Duke Power Company
Oconee Nuclear Station
P.O. Box 1435
Seneca, S.C. 29679

Subject: Oconee Nuclear Station Facility Comments on RO and SRO
License Written Examinations Given January 20, 1992

FILE:	NOTES:	CD NO:	DATE:
KEOWEE HYDRO GENERATOR (KHG)	KEOWEE ELECTRICAL	OC-SPS-KHG-20	2-19-91
		REF: KEE	
		DESIGN: CMR/JAW	91W
		CD NO: OCKHG20.DWG	TRAINING USE ONLY

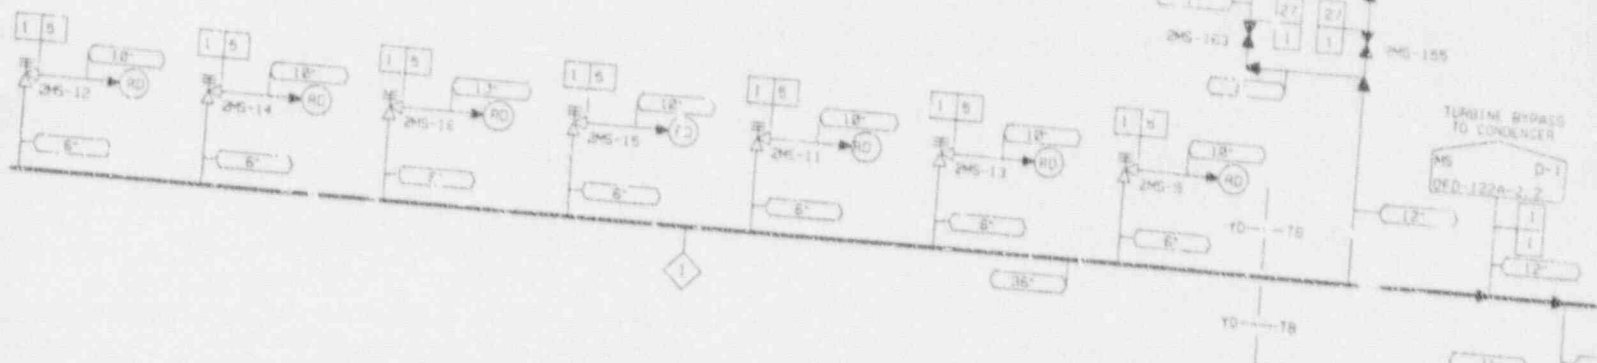
- 9) Facility Comment: #53 RO Exam, choice "c" would be correct if ACB-4 were shut instead of ACB-3. Therefore, both choices "b" and "c" should be considered correct.

Facility Justification: Refer to attached handout drawing of the Keowee Electrical System, OC-SPS-KHG-20. Flowpath for energizing CT4 underground feeder from Keowee Unit #2 via ACB-4 is highlighted on the drawing. This correction was not made during the pre-exam review.

9. Question 53 RO: Comment accepted. The answer key will be changed to reflect that "b" and "c" will be accepted as correct answers.
10. Question 55 RO: Comment not accepted. Since response "b"
61 SRO: correctly describes the plant Main Steam Relief valves designed operation, it will be considered the only correct answer. The answer key will be changed to reflect "b" as the only correct answer.
